Technical Specification
Page Revisions

Consolidated Edison Company of New York, Inc.
Indian Point Unit No. 2
Docket No. 50-247
March, 1987

Safety Assessment

FSAR SECTION 14.1.9 (REVISED)

Figure 14.1-51 A
Loss of Normal Feedwater with 300 gpm
Auxiliary Feedwater

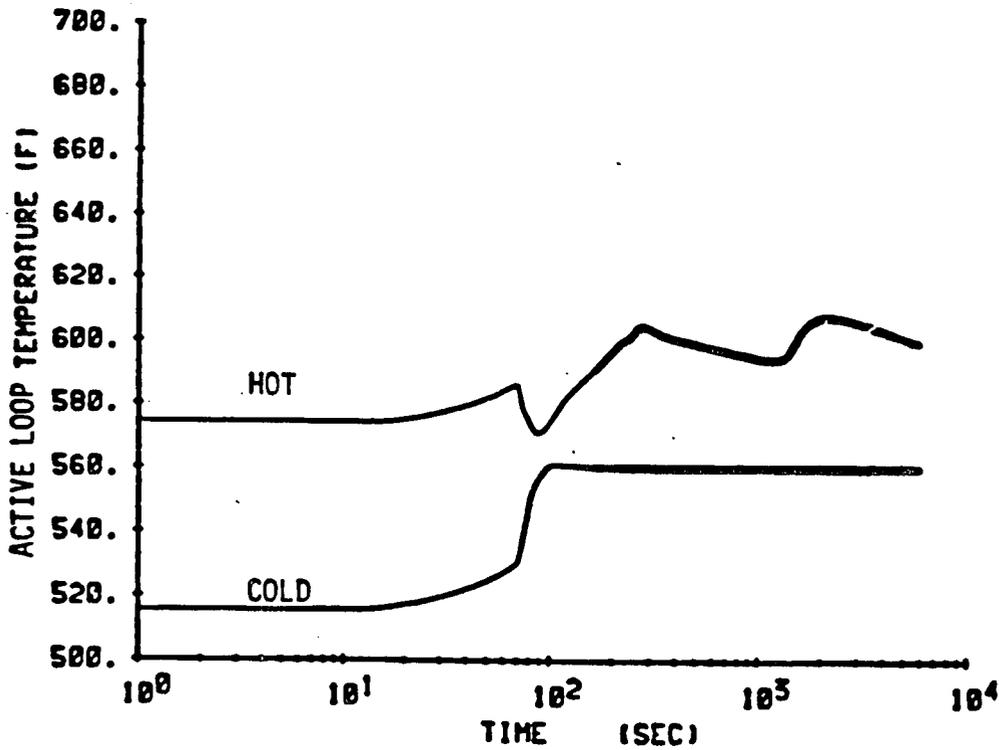
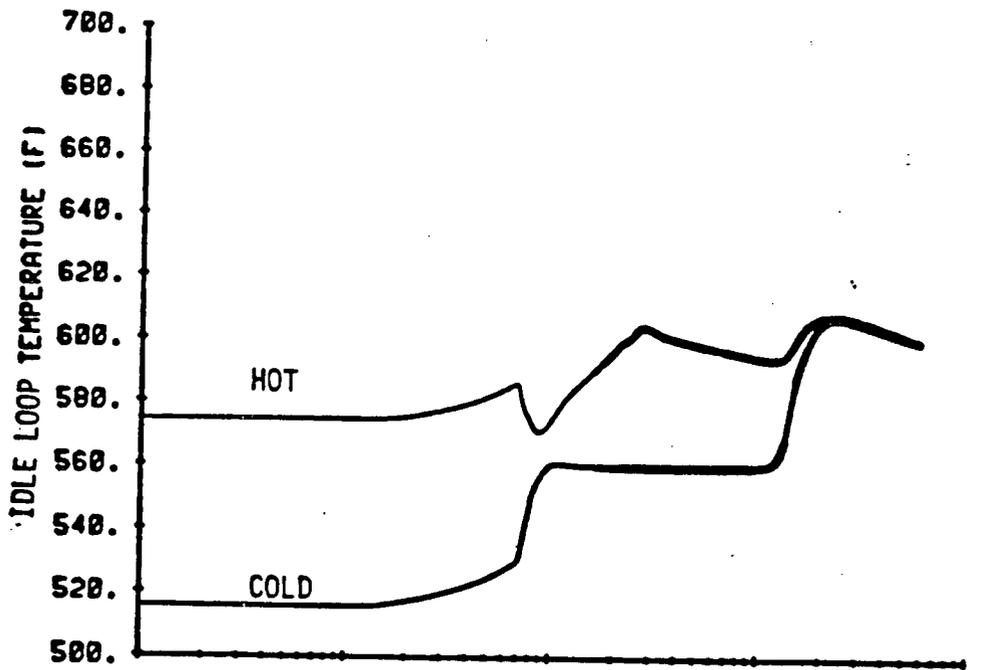
Figures 14.1-51 A, B and C show the plant parameters following a loss-of normal feedwater accident with the assumptions listed above. Following the reactor and turbine trip from full load, the water level in the steam generator will fall because of the reduction of steam generator void fraction and because steam flow continues to dissipate the stored and generated heat. One minute following the beginning of the accident the auxiliary feedwater pump is automatically started, reducing the rate of water-level decrease. The capacity of the auxiliary feedwater pump is such that the water-level in the steam generators being fed does not recede below the lowest level at which sufficient heat transfer area is available to dissipate core residual heat without water relief from the primary system relief or safety valves.

From Figure 14.1-51A it can be seen that at no time is there water relief from the pressurizer. The assumption of more auxiliary feedwater capacity than that of one motor-driven pump or that the initial water level of one steam generator is above the low-low level trip level will of course result in increased margin to the point at which reactor coolant water relief could occur.

The results presented are for a reanalysis of the loss-of-normal-feedwater transient, which accounts for the current power rating (2758 MWt), and a constant auxiliary feedwater flow rate of 300 gpm.
